Service Advisory

CC-490

Date: April 13, 2005

Subject: Deck Cable Hardware Kit (759-04085)

FIGURE 2

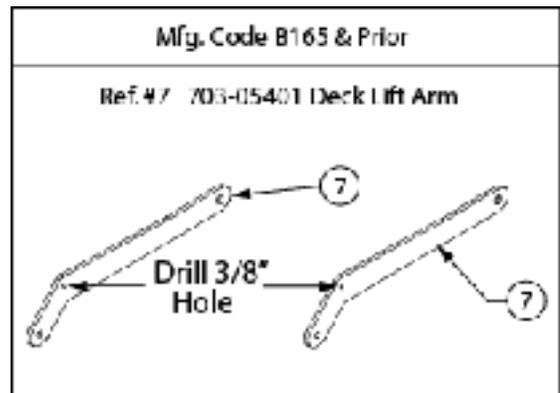
Using a 3/8" drill bit, enlarge the existing 1/4" holes in the deck lift arms 703-05401 as shown in (FIGURE 2.)

FIGURE 1

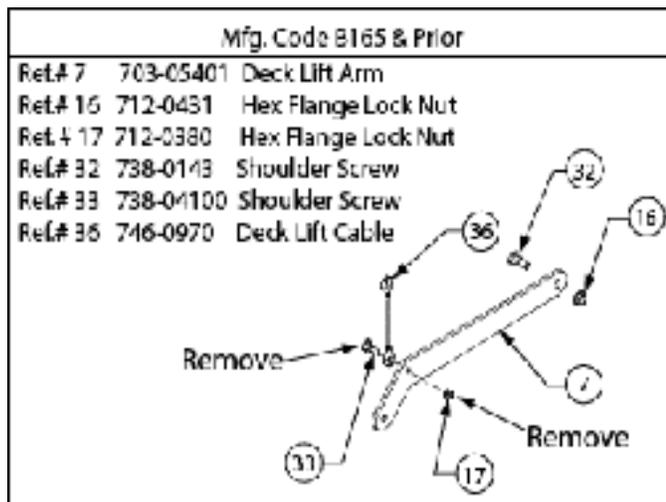
Remove the shoulder bolts 738-04100 and the hex flange lock nuts 712-0380 and discard from both left and right deck lift arms 703-05401. (FIGURE 1.)

Reattach the cables using the clevis pin, washer and cotter pin provided in each of the Deck Cable Hardware Kits 759-04085. Use the clevis pins in place of the discarded 738-04100 shoulder bolts, and the washers and cotter pins to retain the cables to the deck lift arms.

FIGURE 3

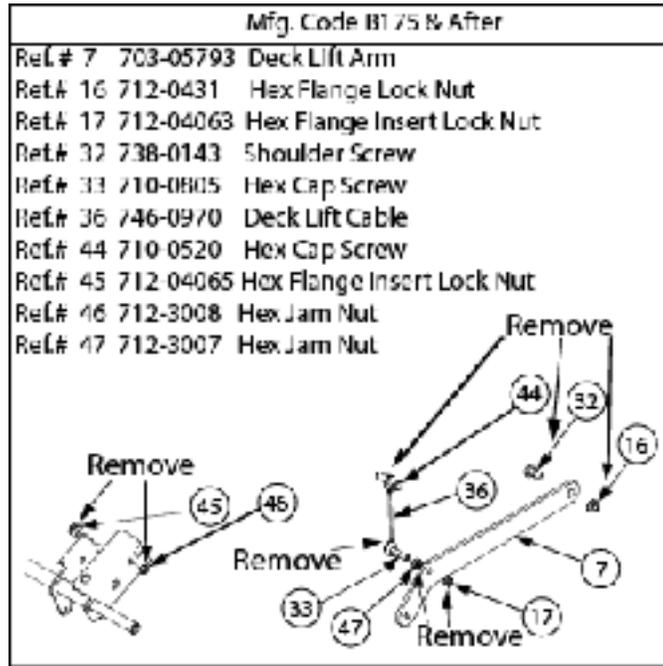
Remove the hex cap screws 710-0805, the hex jam nuts 712-3007 and the hex flange insert lock nuts 712-04063 and discard from both left and right deck lift arms 703-05401. (FIGURE 3.) Discard all removed hardware.

Remove the hex cap screws 710-0520, the hex jam nuts 712-3008 and the hex flange insert lock nuts 712-04065 from the deck lift shaft assembly 603-04160. Retain the left and right cables 746-0970 and discard all other removed hardware. (FIGURE 3).

Reinstall the cables using the clevis pin, washer and cotter pin provided in each of the Deck Cable Hardware Kits 759-04085 (Qty. 4 needed). Use the clevis pins in place of the discarded 738-0805 hex cap screws and the 710-0520 hex cap screws. Use the washers and cotter pins to retain the cables to the deck lift arms and the deck lift shaft assembly.

FIGURE 4

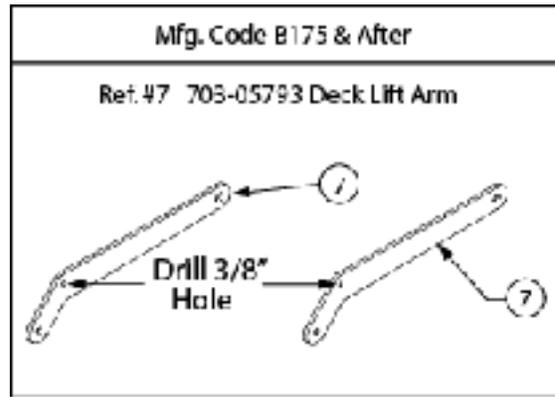
Using a 3/8" drill bit, enlarge the existing 5/16" holes in the deck lift arms 703-05401 as shown in (FIGURE 4.)
